ADDENDUM 002

DATE: July 23, 2025
COMM NO: 24058.001
PROJECT: VINTON War Memorial Renovation

TO: All Bidders
FROM: Shawn Emmons
RE: Addendum No. 2

A2-1

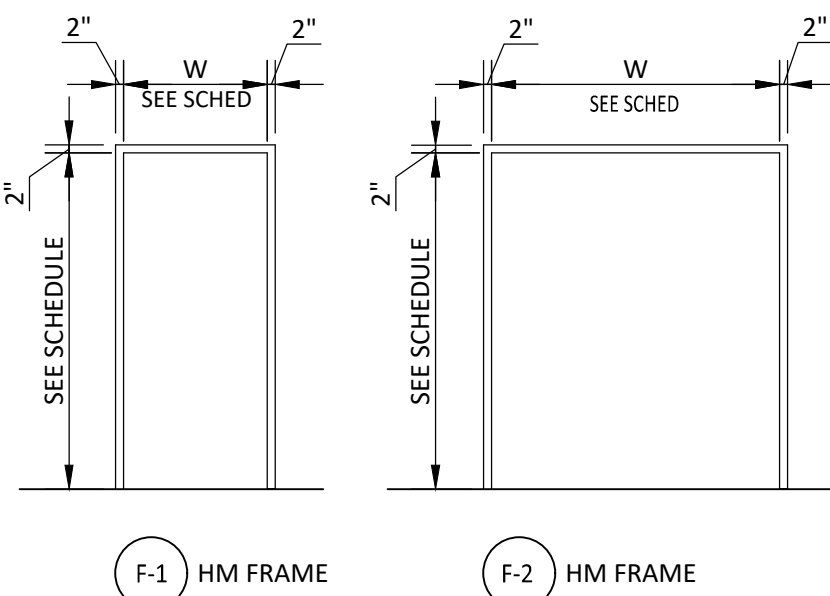
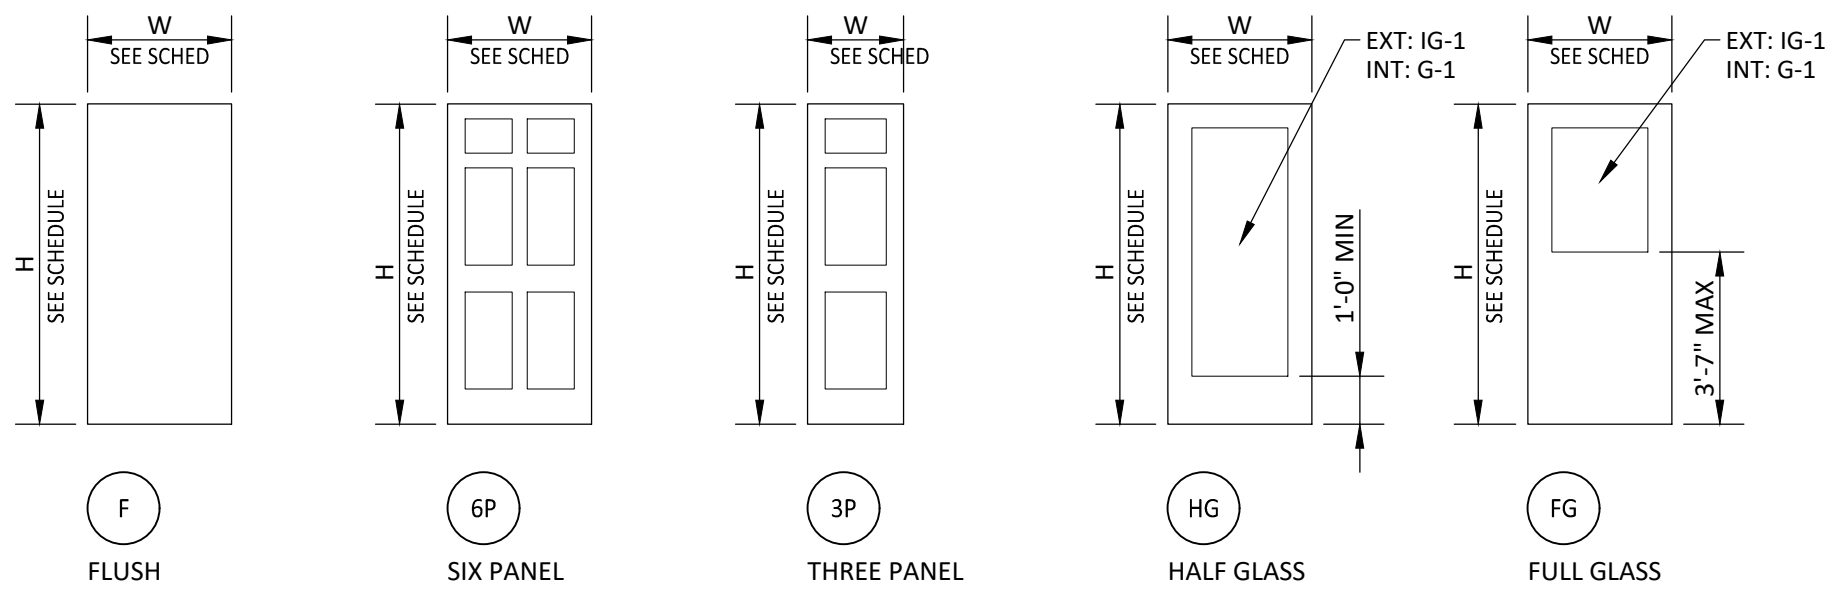
REPLACE sheet dated JUNE 20, 2025 with Sheet A2-1 identified with Delta 2, ADD NO 2, dated 7/23/25.
See added Door Head and Jamb Detail identification, Threshold identification, and Door Schedule Notes.

- NOTE 13: FOR HEAD & JAMB DETAILS, SEE DOOR DETAILS A2-3.4.
- NOTE 14: T-1: PROVIDE ZERO, SADDLE THRESHOLD, 545. AT UNLEVEL CONDITIONS, PROVIDE ZERO, OFFSET THRESHOLD, 102.

- NOTE 15: T-2: PROVIDE ZERO, RAMP THRESHOLD, 234, OR A COMBINATION OF RAMPS 233 & 234 AT DOORS WHERE THERE IS FLOOR LEVEL CHANGES IN WOOD FLOORING RESULTING FROM LEVELING THE BALLROOM FLOOR.

- NOTE 16: T-3: PROVIDE 4" WIDE HARDWOOD THRESHOLD STAINED TO MATCH WOOD FLOORING. EDGES SHALL BE CHAMFERED TO PROVIDE 1:2 SLOPE. ROUTE BOTTOM TO ACCOUNT FOR THE DIFFERING ELEVATIONS OF WOOD FLOOR ON ONE SIDE AND THINSET TILE ON THE OTHER SIDE. FLOOR LEVEL CHANGE = 1/4" MAX. TOTAL HEIGHT OF THRESHOLD MEASURED FROM ADJACENT FLOOR FINISHES = 1/2" MAX.

- NOTE 17: T-4: PROVIDE 4" WIDE HARDWOOD THRESHOLD STAINED TO MATCH WOOD FLOORING. EDGES SHALL BE CHAMFERED TO PROVIDE 1:2 SLOPE. ROUTE BOTTOM TO ACCOUNT FOR THE DIFFERING ELEVATIONS OF VARIOUS FLOOR FINISH THICKNESSES. FLOOR LEVEL CHANGE = 1/4" MAX. TOTAL HEIGHT OF THRESHOLD MEASURED FROM ADJACENT FLOOR FINISHES = 1/2" MAX.

SHEET
A2-2

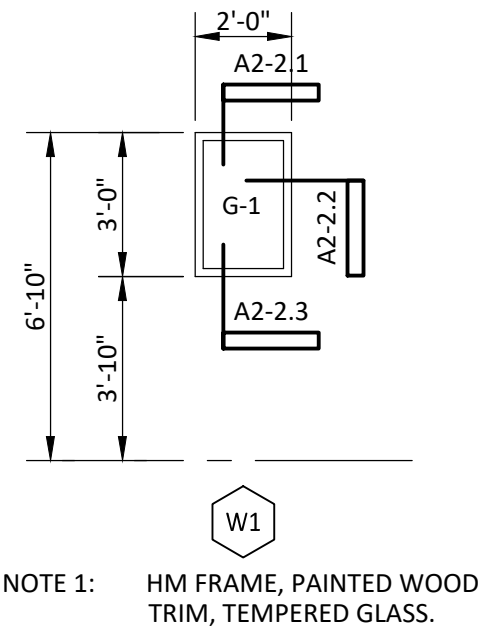
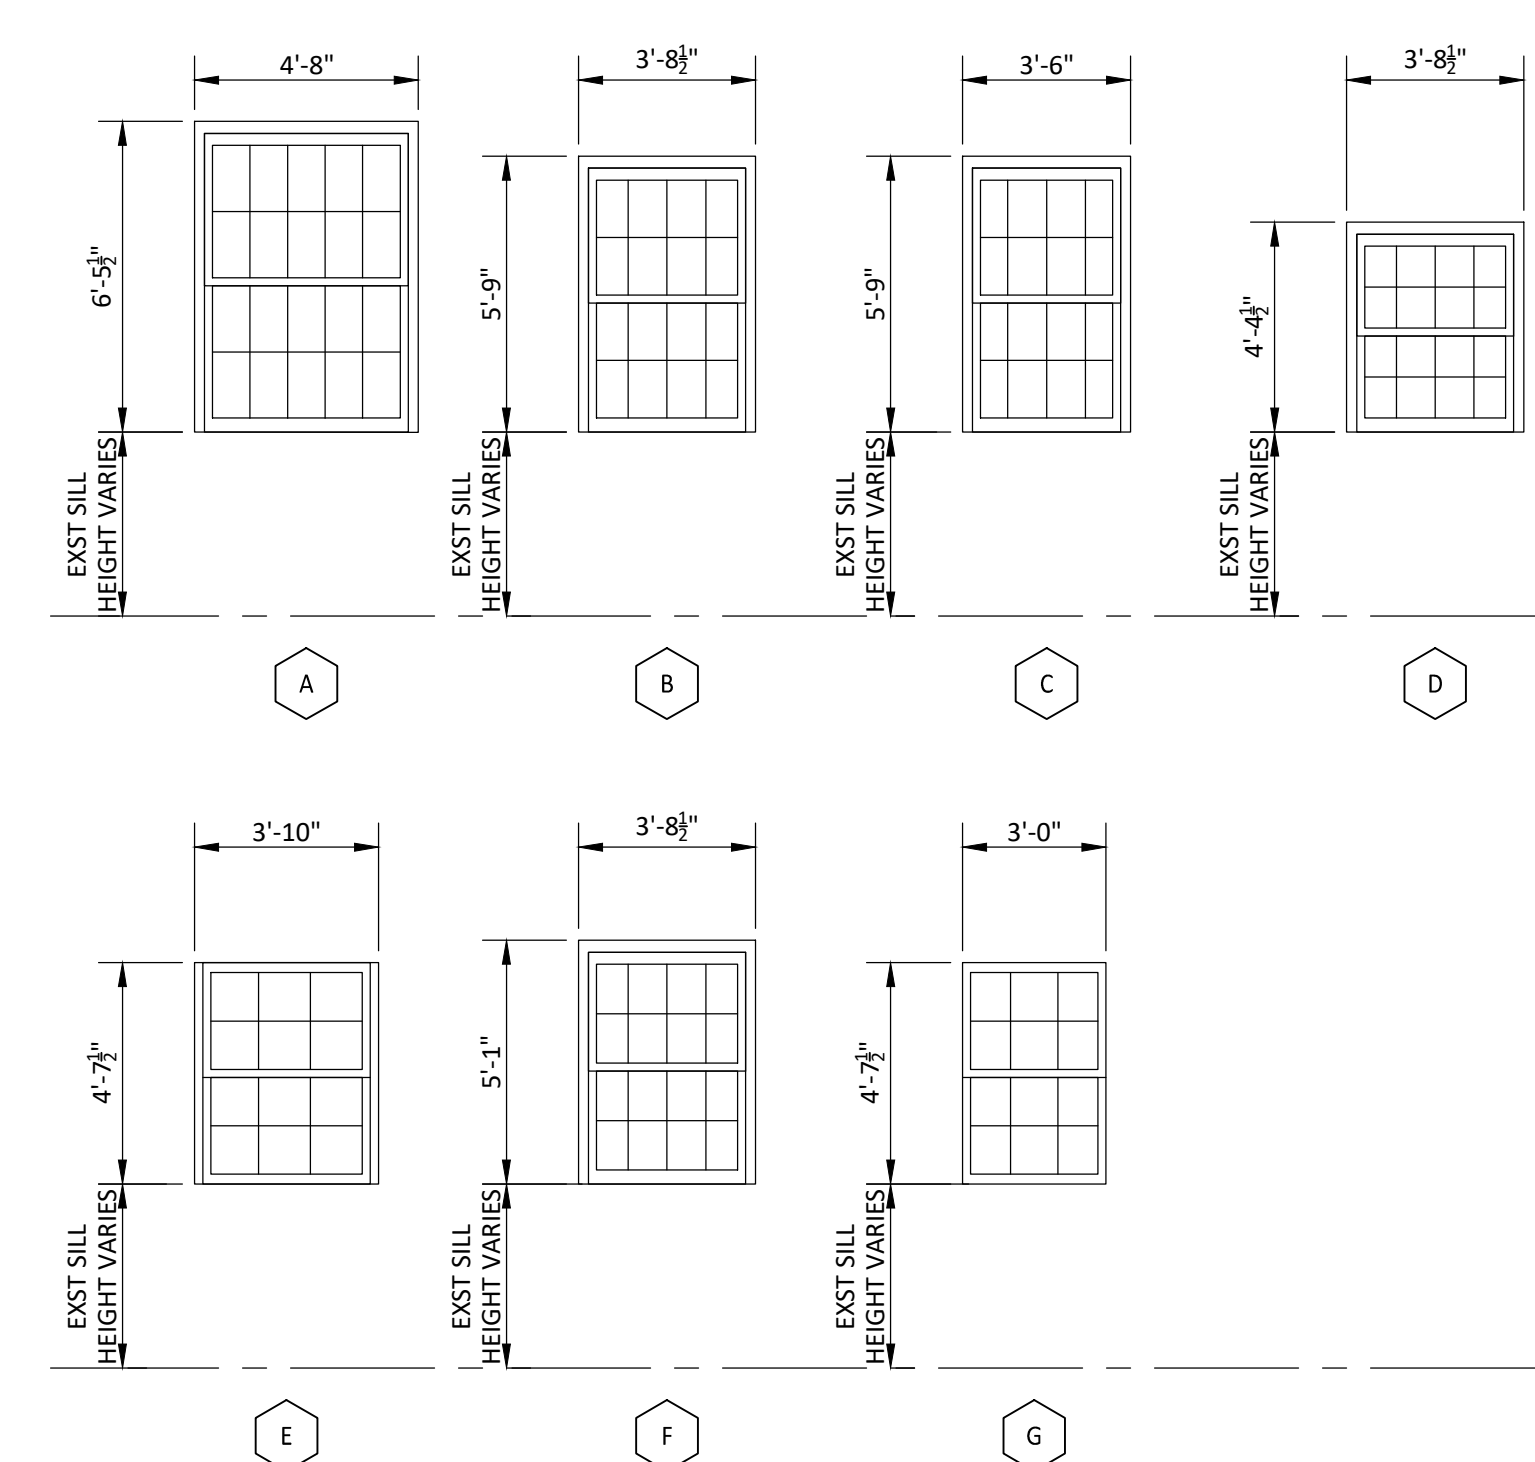
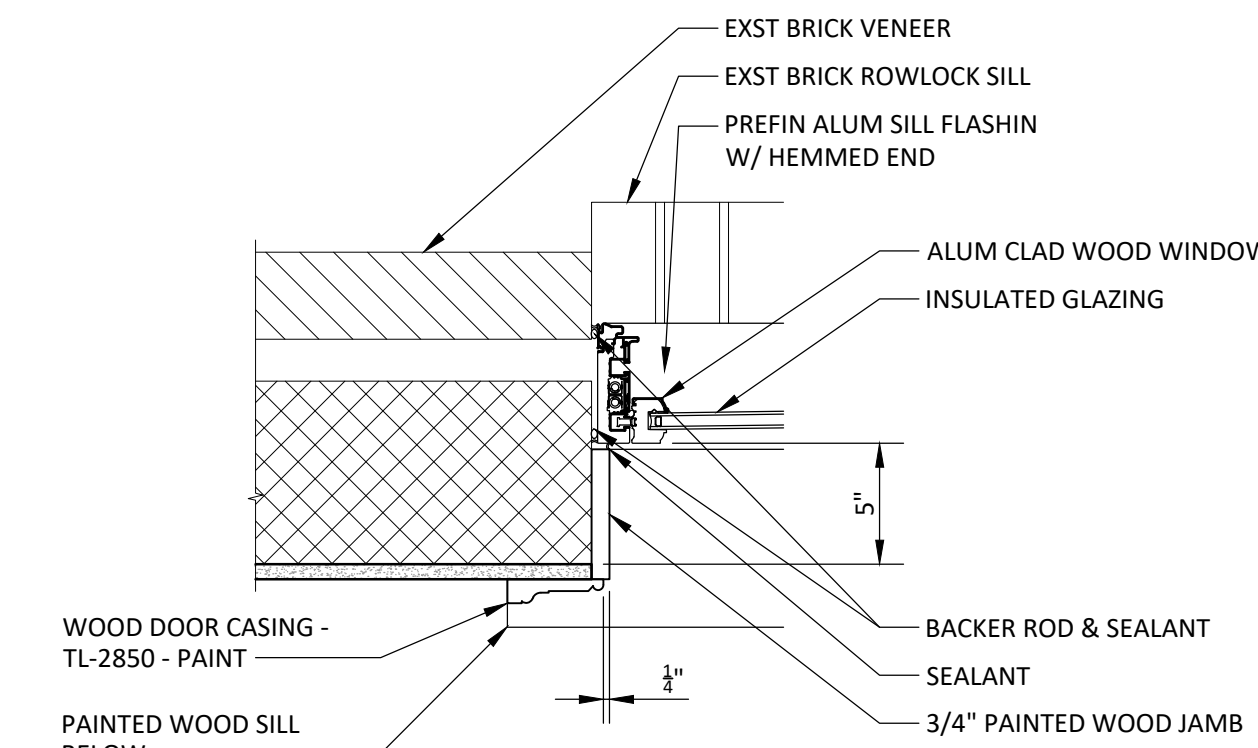
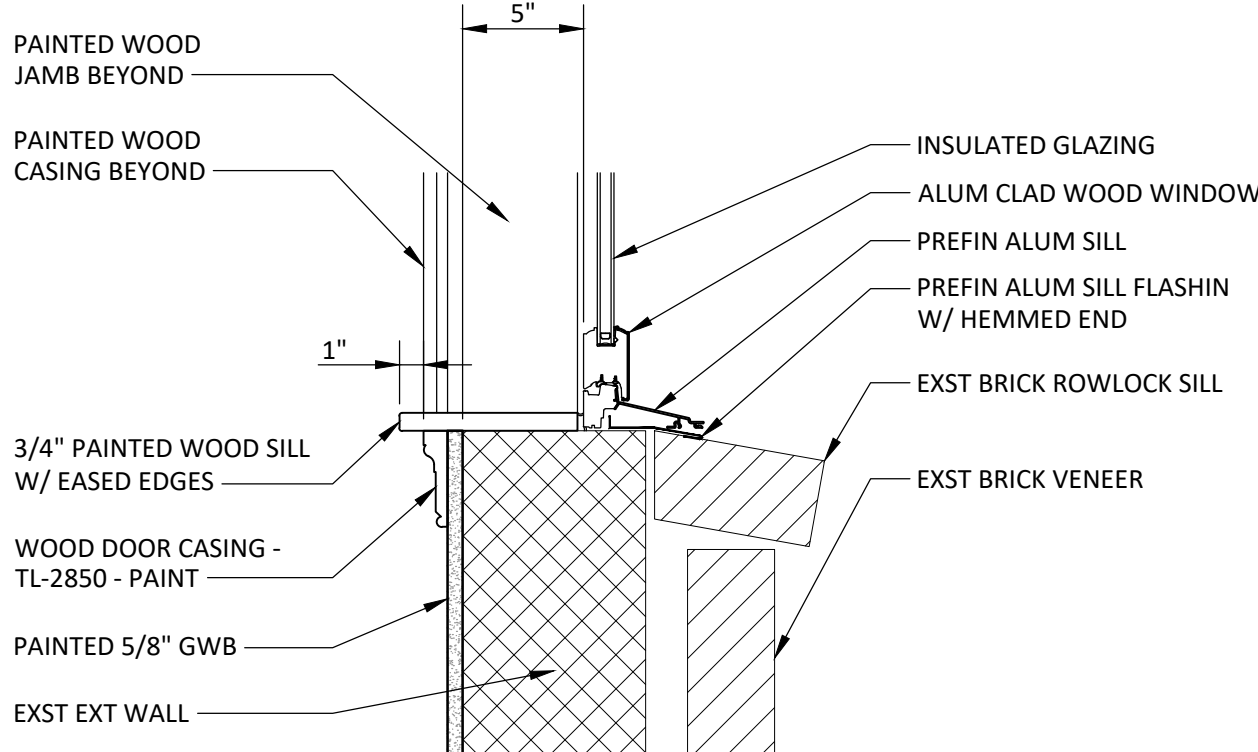
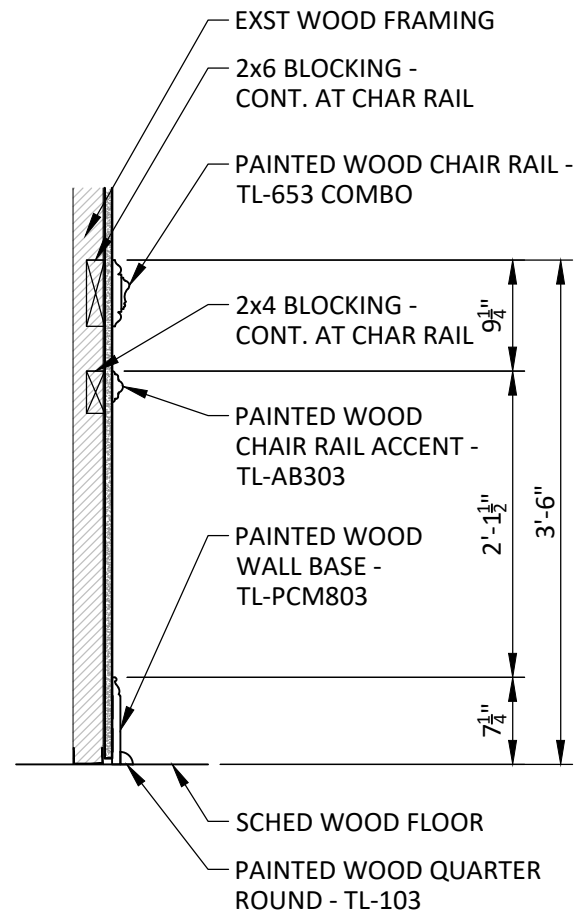
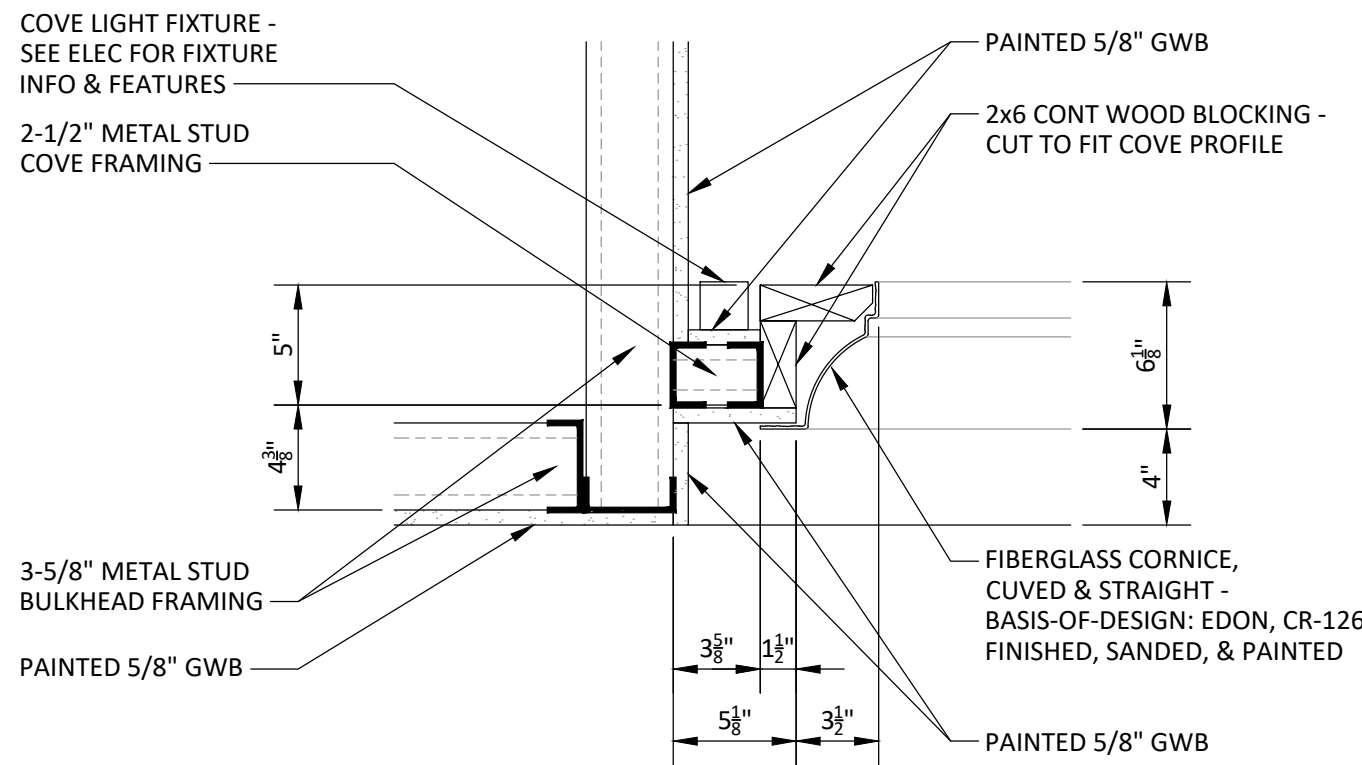
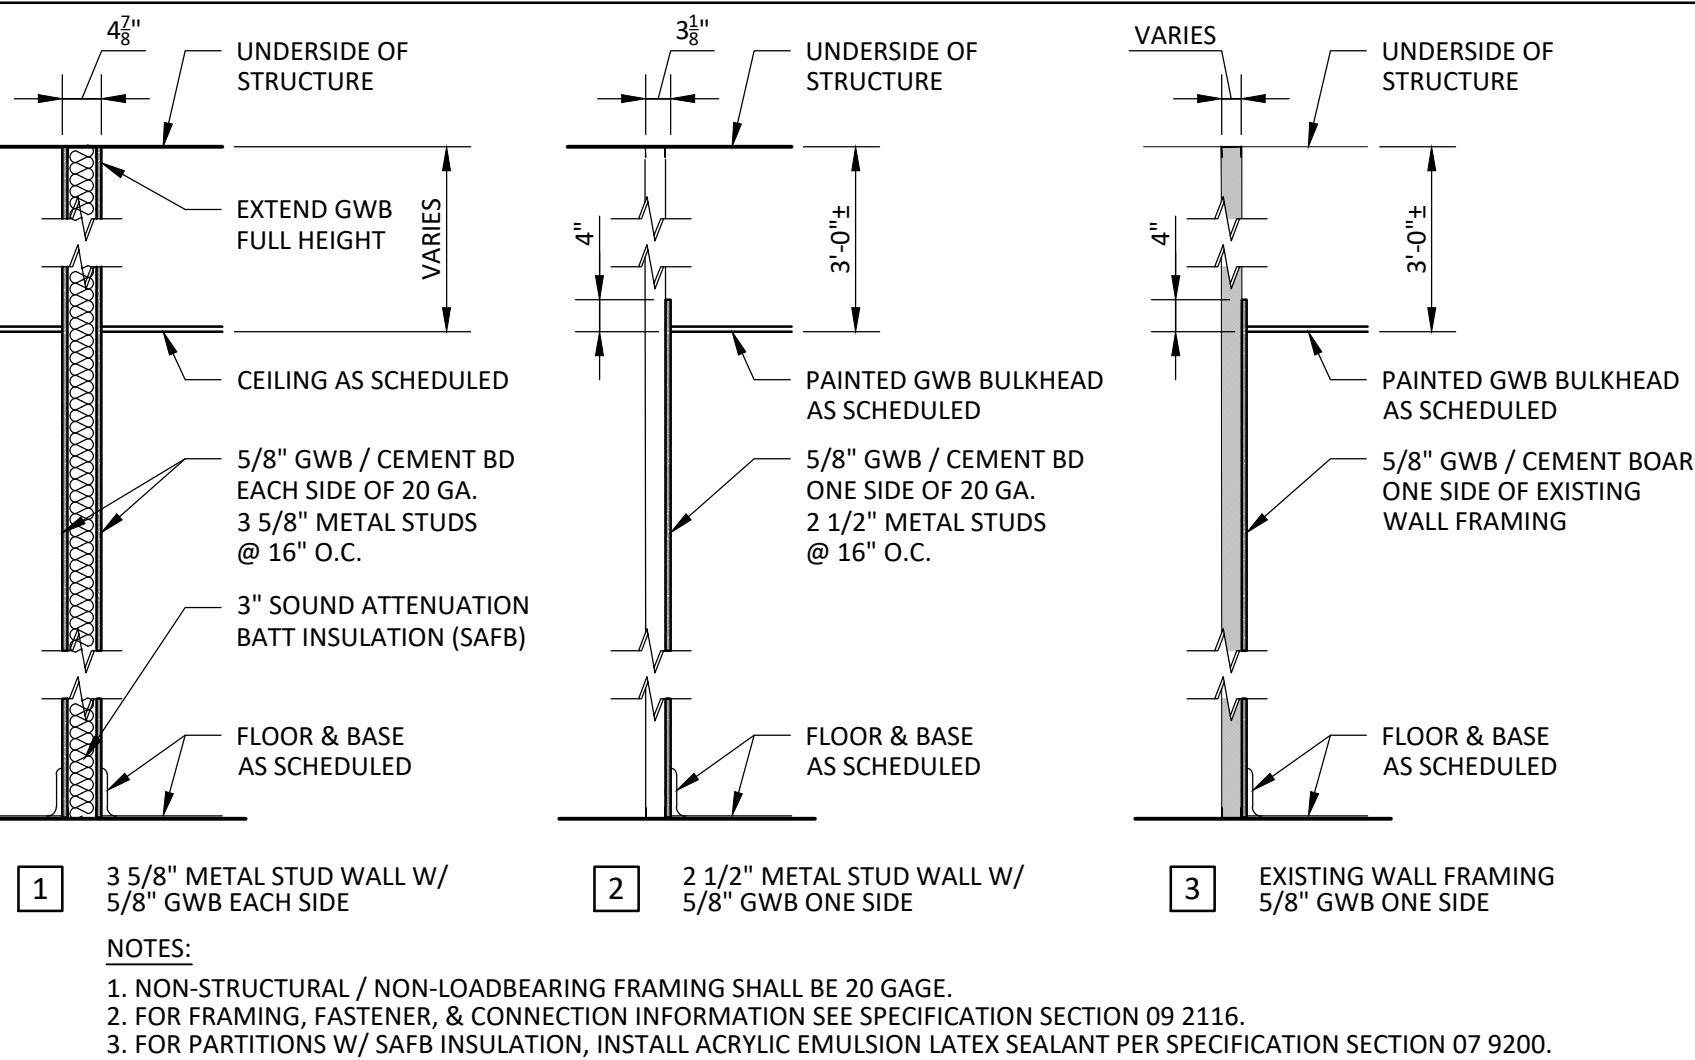
REPLACE sheet dated JUNE 20, 2025 with Sheet A2-2 identified with Delta 2, ADD NO 2, dated 7/23/25.
See added Interior Window Details A2-2.1, A2-2.2, & A2-2.3.
See added Exterior Window Details A2-2.4, A2-2.5, & A2-2.6.
See added Ballroom Trim Detail A2-2.7 & Typical Cove Detail A2-2.8.
See added 3" Sound Attenuation Batt Insulation for Partition Type 1 in PARTITION TYPES.
